[Docket No. 2003-SW-10-AD]

Airworthiness Directives; Eurocopter France Model AS355E, F, F1, F2, and N Helicopters

ACTION: Notice of proposed rulemaking

Figure 1

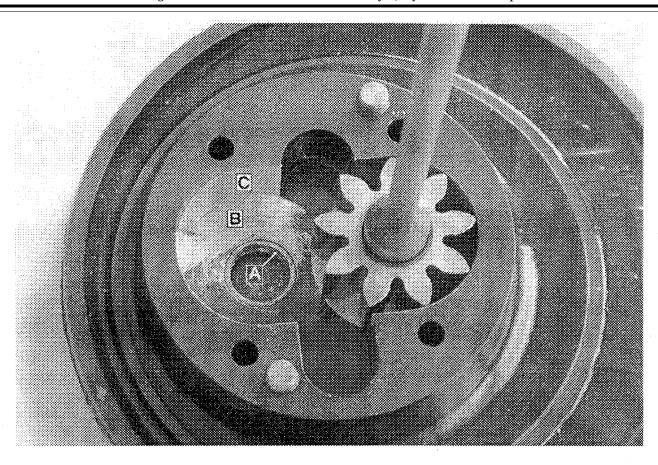
- (b) Before further flight, if any sludge is found on the chip detector, inspect the numb.
- (c) Before further flight, if the oil appears dark in color when it is observed through the MGB oil-sight glass, take an oil sample. If the oil taken in the sample is dark or dark purple, before further flight, inspect the pump.
- (d) While inspecting the pump, if you find any of the following, replace the MGB and the pump with an airworthy MGB and pump before further flight:
 - (1) Crank pin play,
- (2) Out of round bronze bushing (A of Figure 1),
 - (3) Offset of the driven gear pinion,
 - (4) Metal chips, or
 - (5) Wear (C of Figure 1).

Note 2: If wear is present in the B area only as depicted in Figure 1, replacing the MGB and the pump is not required.
